ADDENDUM #2

Project: Phase #2 of Finish Renovations at
John Wood Elementary School.
6100 East 73rd Ave
Merrillville, Indiana 46410
Architect's Project #25058

This addendum forms a part of the Bid Documents and modifies the original Bid Documents dated 1/29/2026 as noted below. Acknowledge receipt of this addendum in the space on the Bid Form. Failure to do so may subject bidder to disqualification.

SHEET
A
1.0.1

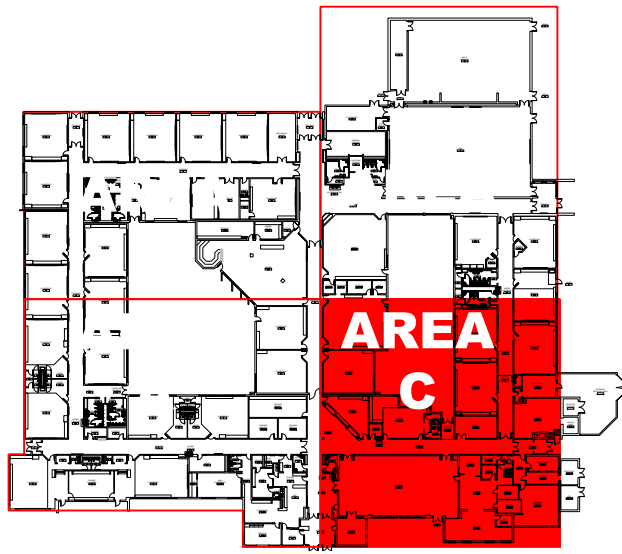
5. See attached Revised Drawing Sheet A1.0.1 – _Partial Floor Plan – Area A – Demolition_ - This plan shows clouded and tagged revisions dated 02-17-2026.

SHEET
A
1.0.3

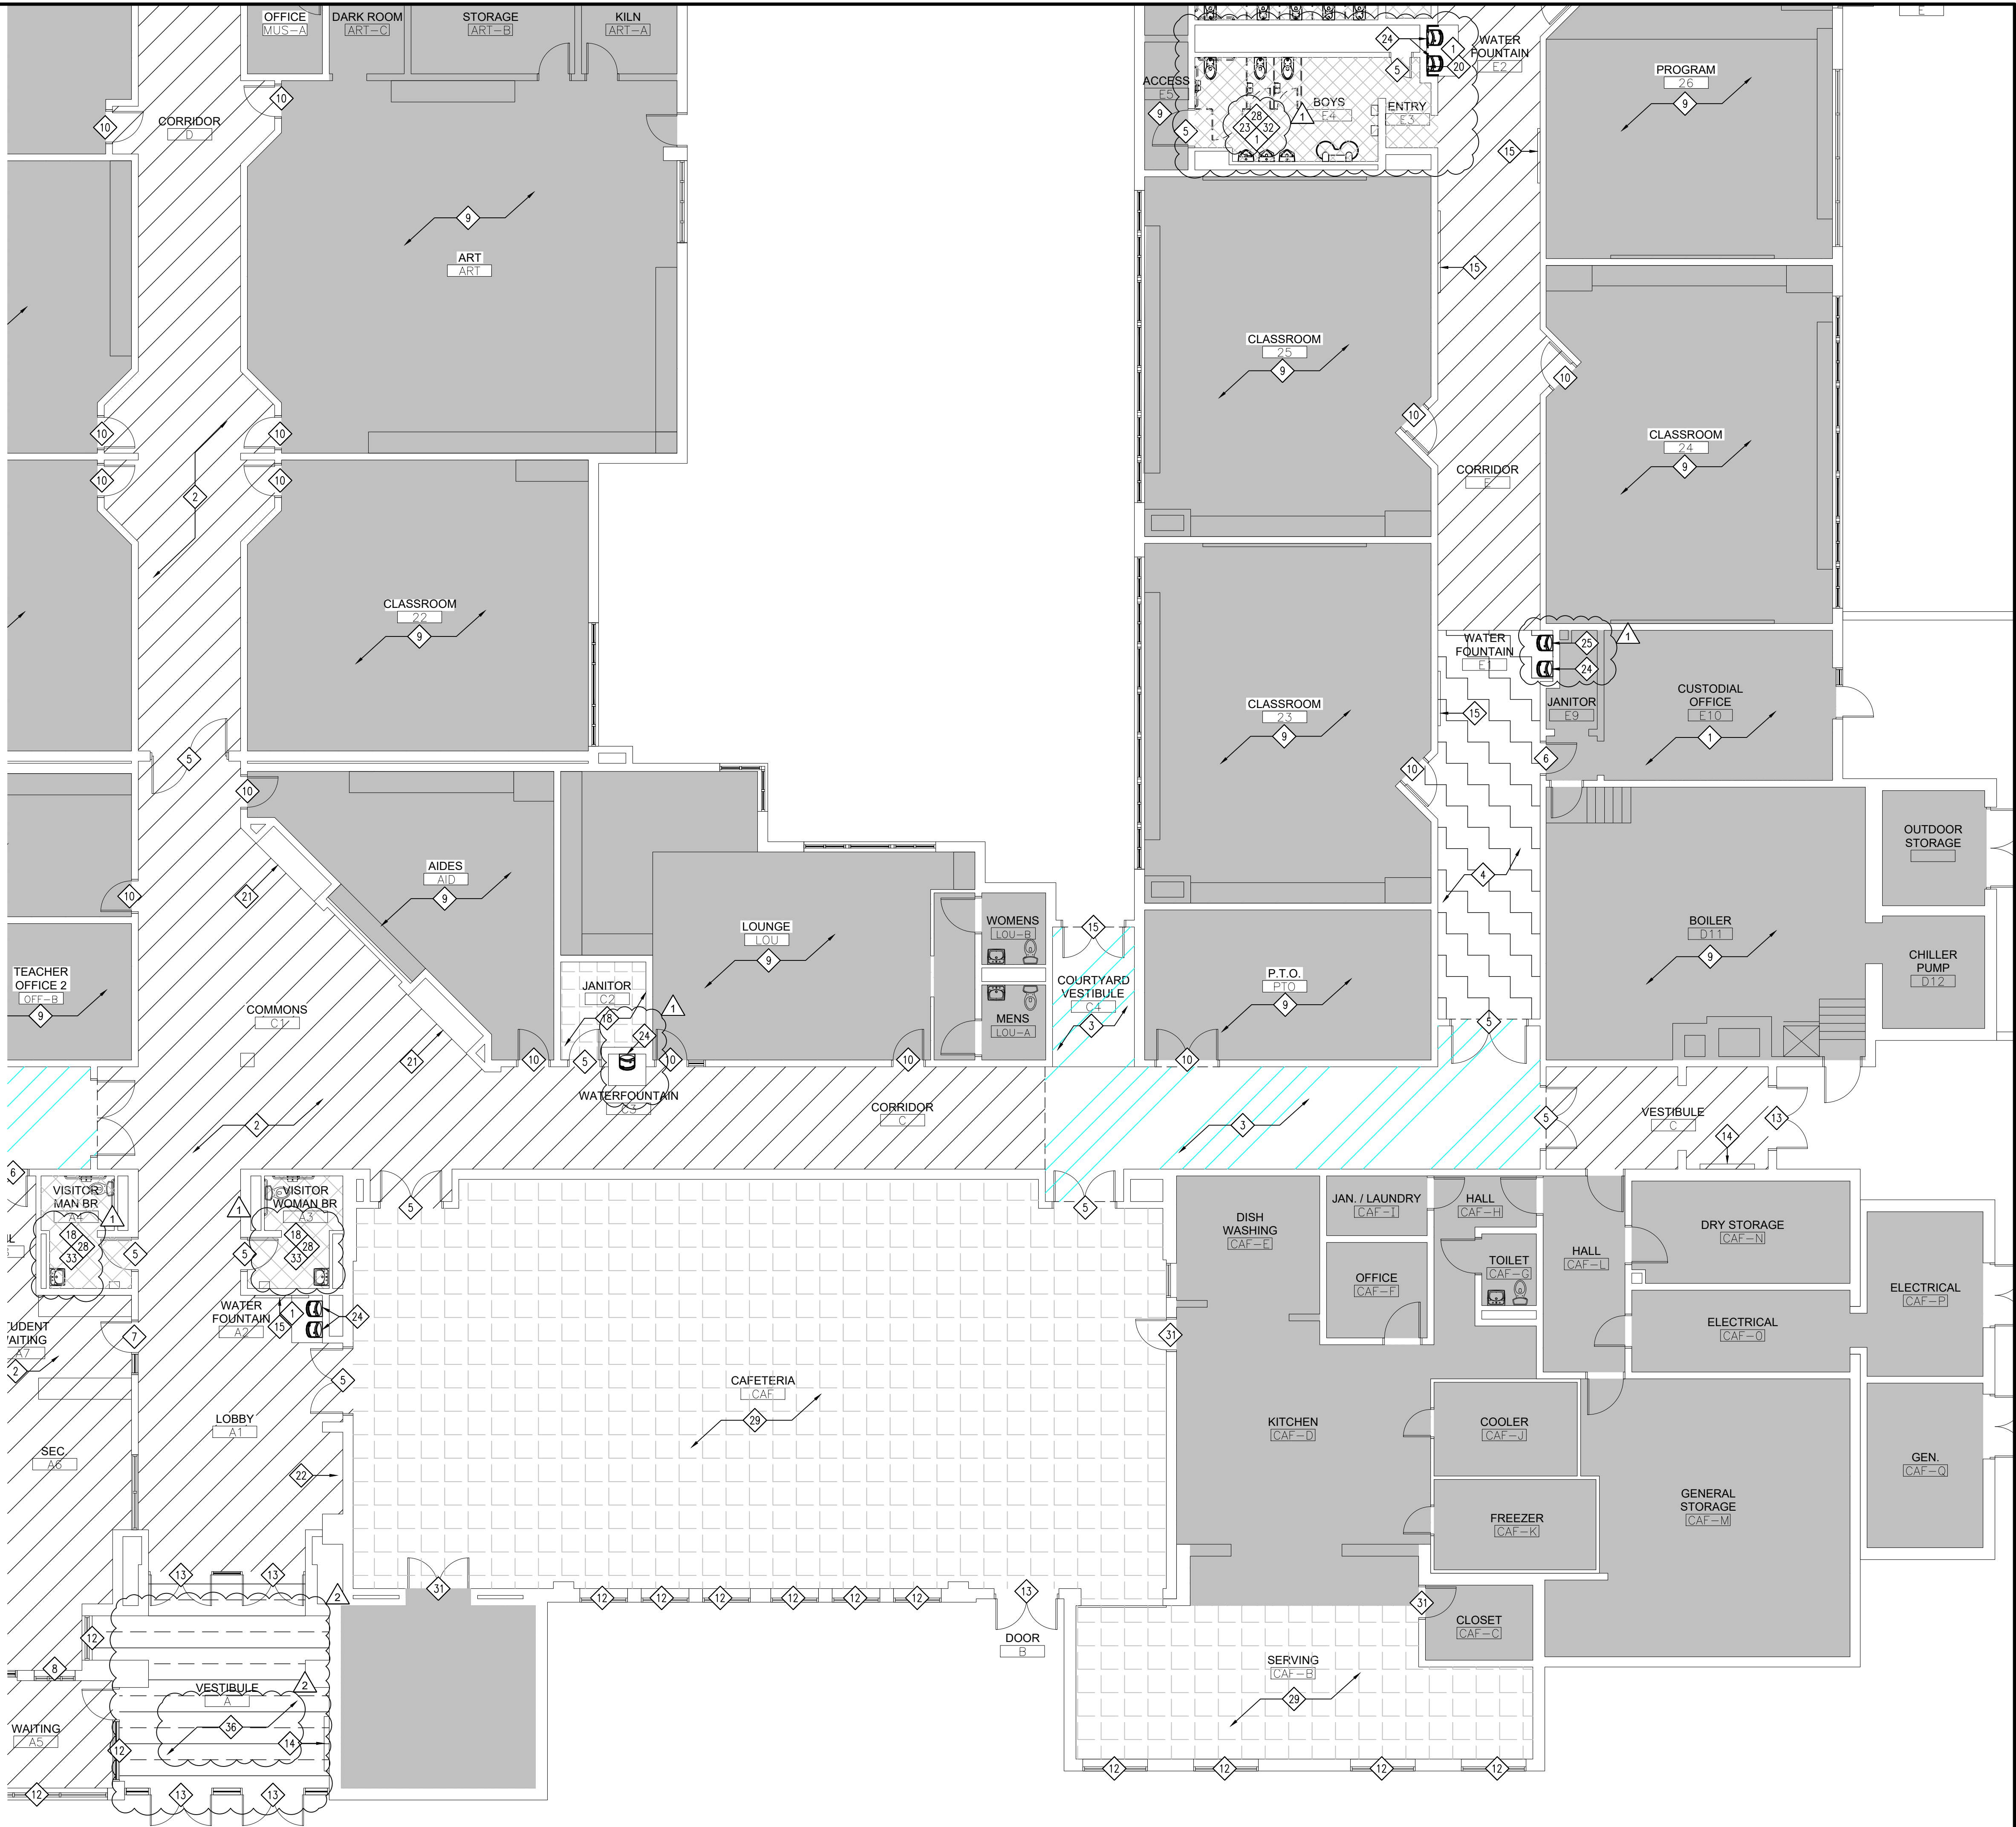
6. See attached Revised Drawing Sheet A1.0.3 – _Partial Floor Plan – Area C – Demolition_ - This plan shows clouded and tagged revisions dated 02-17-2026.

SHEET
A
1.0.4

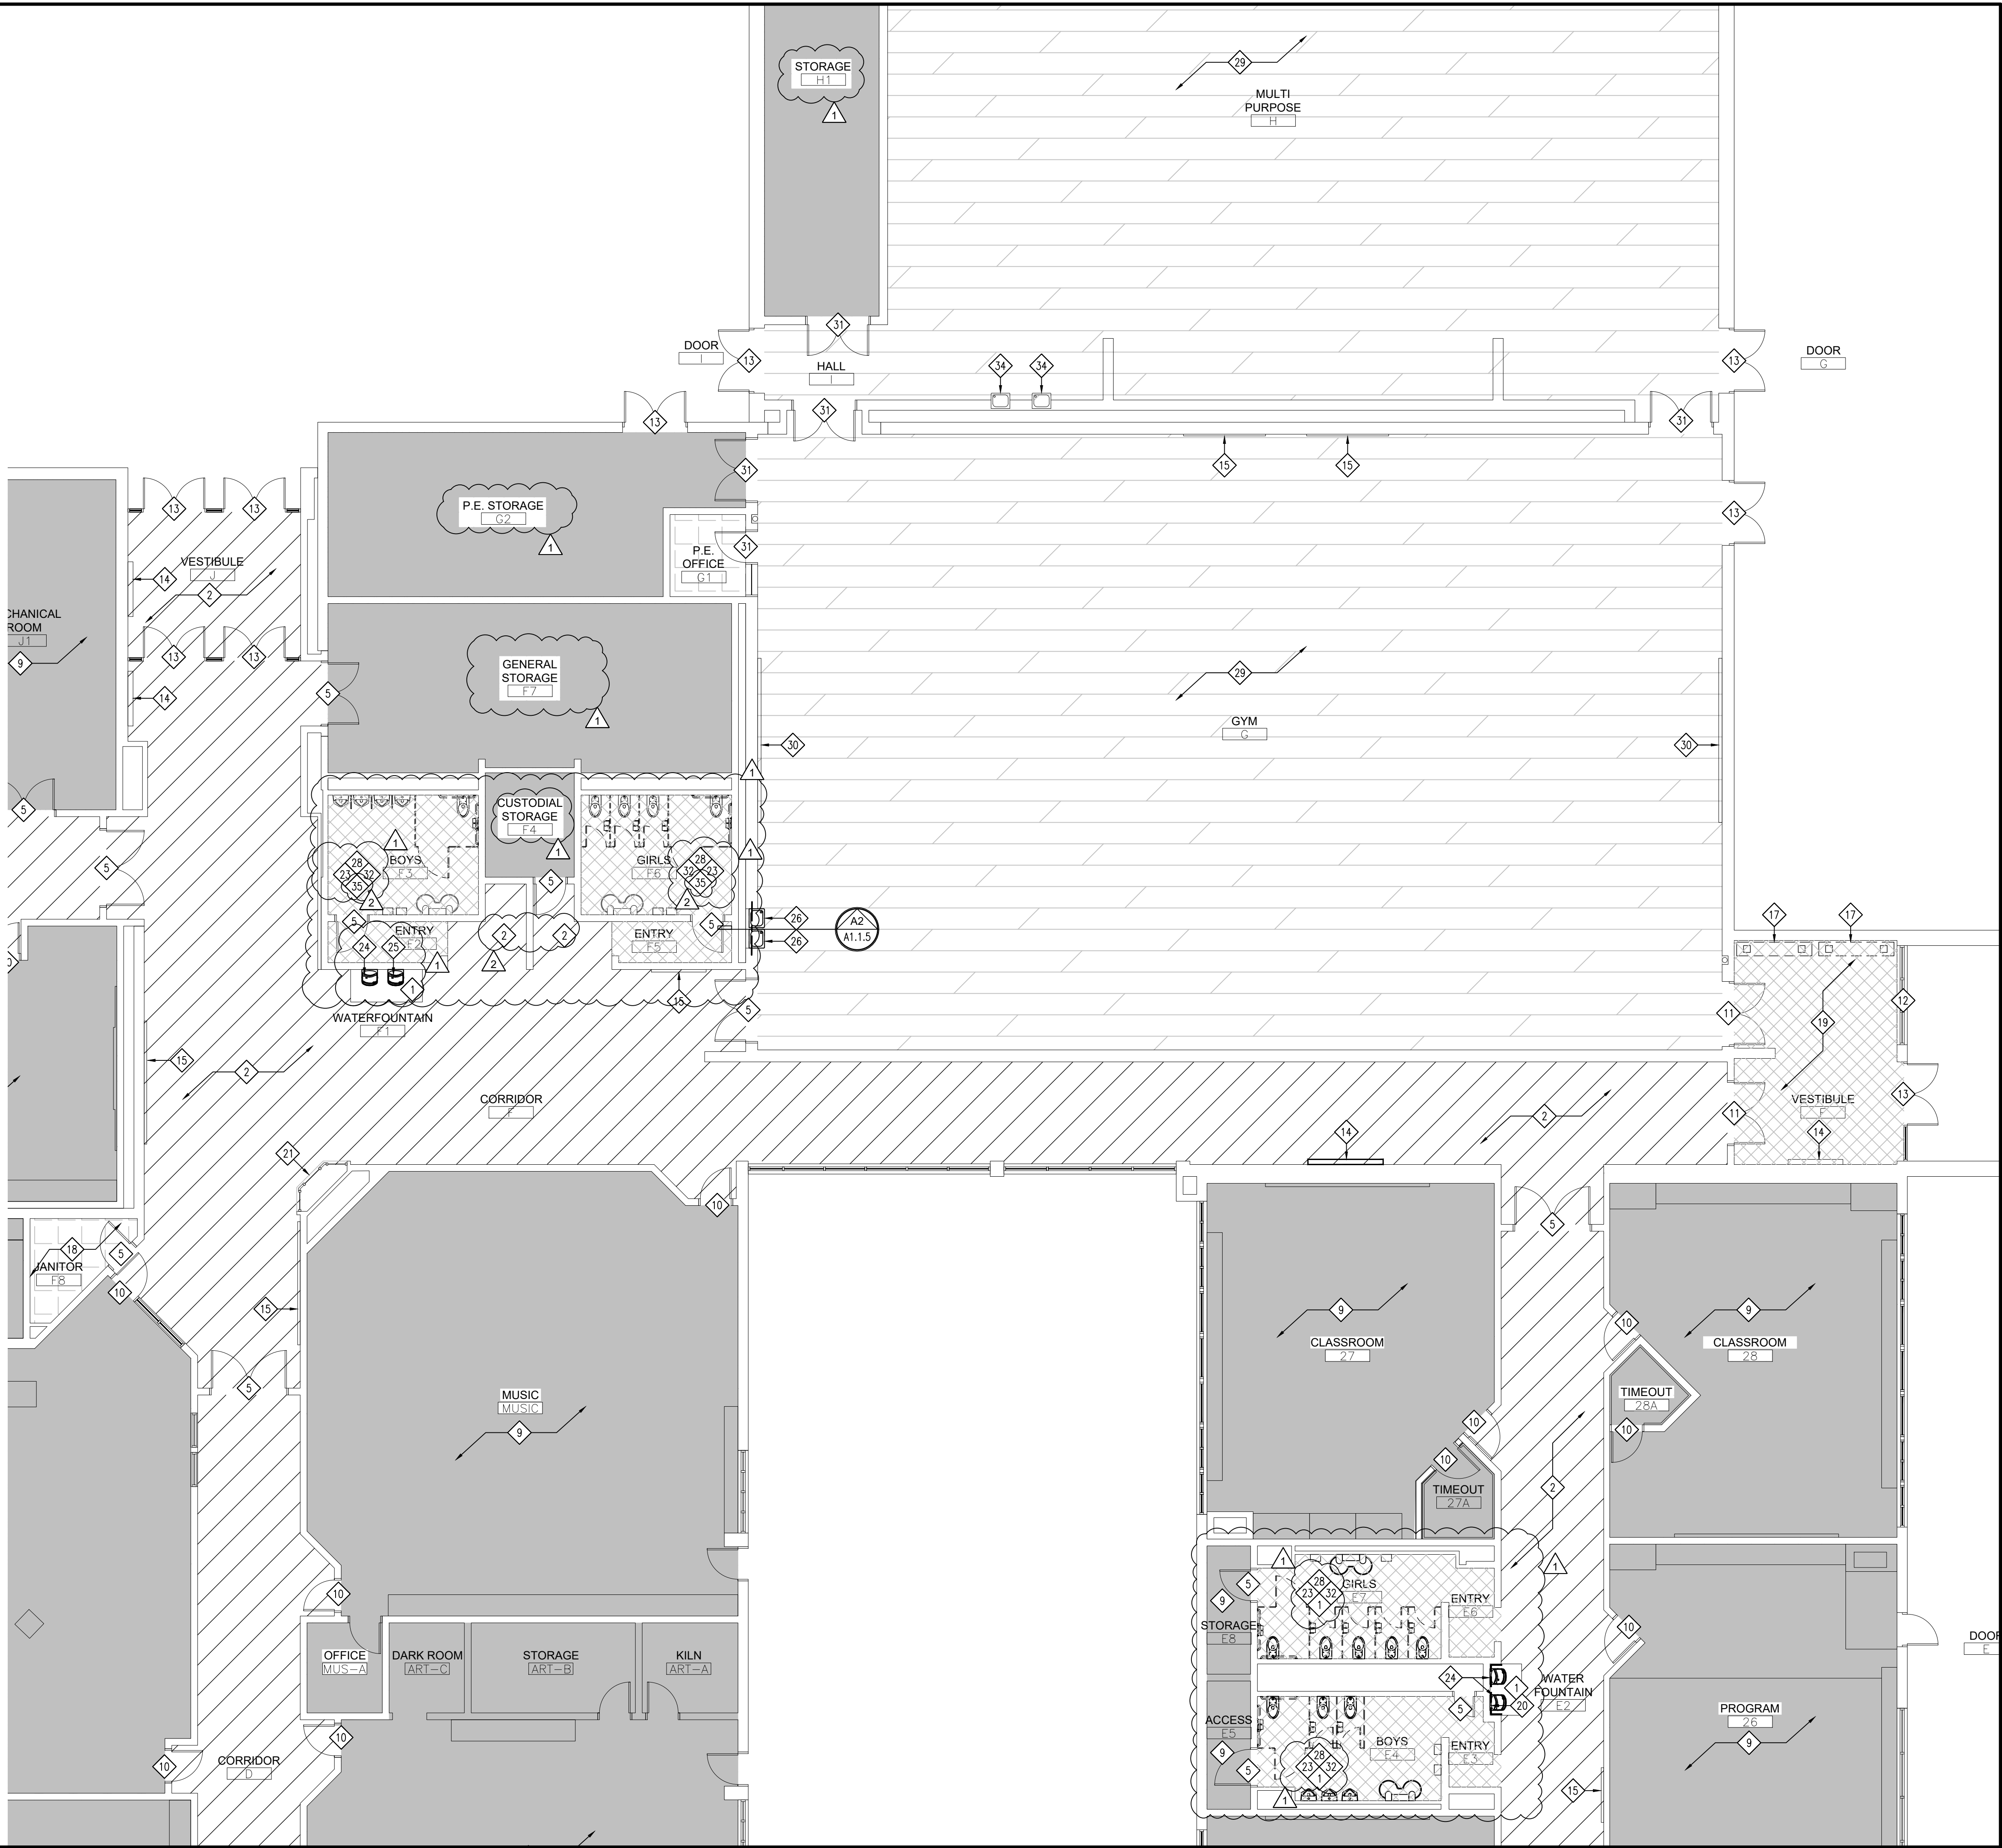
7. See attached Revised Drawing Sheet A1.0.4 – _Partial Floor Plan – Area D – Demolition_ - This plan shows clouded and tagged revisions dated 02-17-2026.
